City of Sydney Comment - 1 b)

Figure 9: Hickson Road elevation showing proposed location of new awnings.
Source: Tonkin Zulaikha Greer Architects

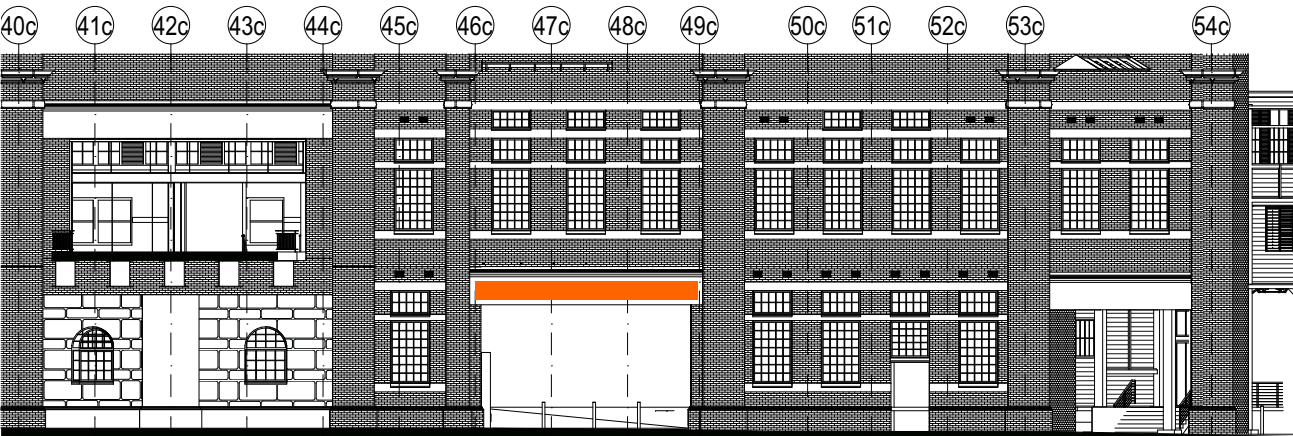
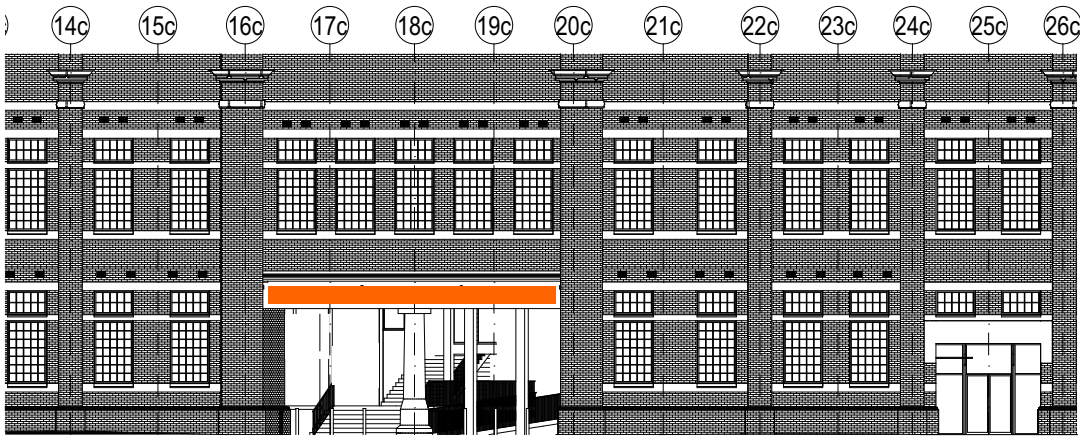
It is noted that awnings are not characteristic of the Hickson Road elevation of the Walsh Bay Shore Sheds. If the Department is minded to approve new awnings, they should be simply detailed, confined to entries and be sympathetic to the industrial character of the facades. The awnings should be designed with input from the applicant's heritage consultant.

The new awnings to Hickson Road will be simply detailed, confined to entries and sympathetic to the industrial character of the original facade. The design of the awnings will be further developed with input from the applicant's heritage consultant.
